Access Compliance Report

Public Rights-of-Way

Intersection ID: 8157	Main Street: N_TRYON_ST	Cross Street: ORR_RD	Location: NE
ADA ID: B417D5434EE2	Ramp Type: Perp	Initial Pass/Fail: Pass	Overall Compliance: No
Severity Score: 0			
Codes/Mitigation Info/Possible Solution		Field Measurements/Component Compliance

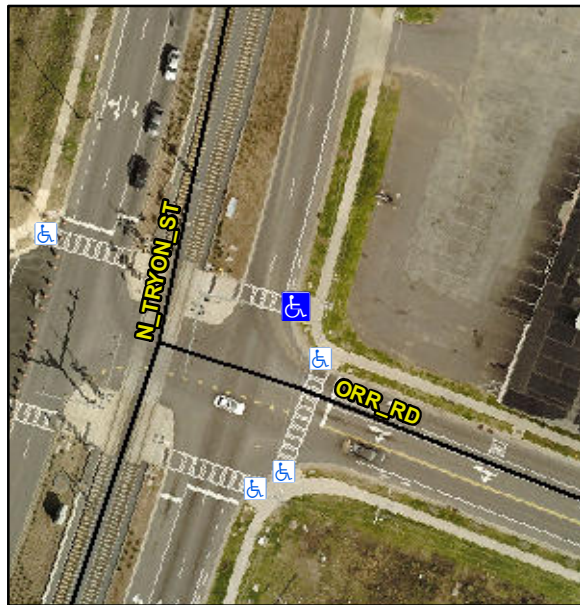
PROW/ADA:

R304.5.3, R302.7

Possible Solutions:

**Remove & Replace Landing.
Remove & Replace Gutter.**
